**From:** [REDACTED]  
**To:** [REDACTED]  
**Sent:** 2/24/2021 9:16:37 AM  
**Subject:** RE: O8W-PM 35217268, 35224712, 35224713 - Bucks Creek 1101 Phase 1,2&3 - Pre-Engineering Meeting

**Subject:** O8W-PM 35217268, 35224712, 35224713 - Bucks Creek 1101 Phase 1,2&3 - Pre-Engineering Meeting

PM 35217268 (Phase 1)

Rock Creek

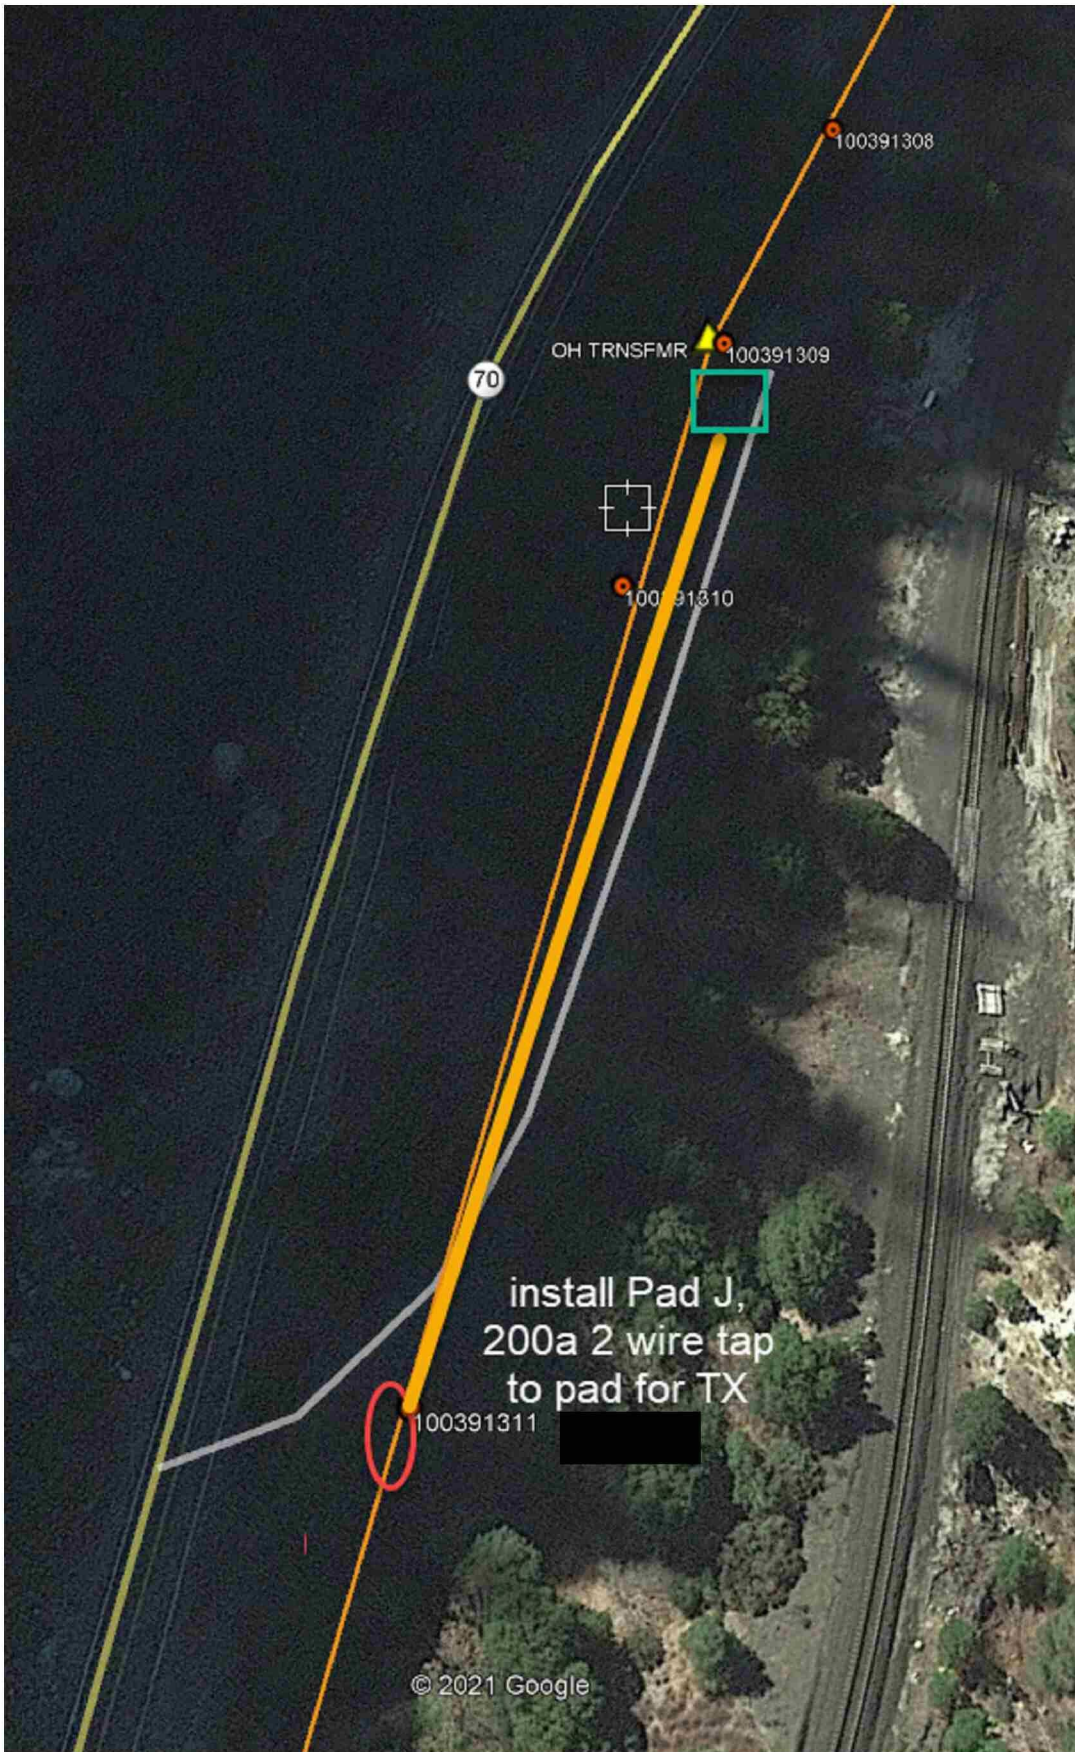
Also need to see what Hydro is willing to do with the TX for the penstock metering valve at Rock Creek PH. It will be a long way up from the

Need to see if Hydro has GPR data for the Hwy 70 road bed to see if we can get 42" minimum cover and keep clearance over any hydro facilities.

Merlin can go back like we just did [redacted] Poe. Pad on the Highway and tension secondary 1/0 ASCR across the river. We can negotiate to move the [redacted] service point with my MSA electrician.

the first tunnel window, leave the old TX pole, top it and use to splice in UG service feed.
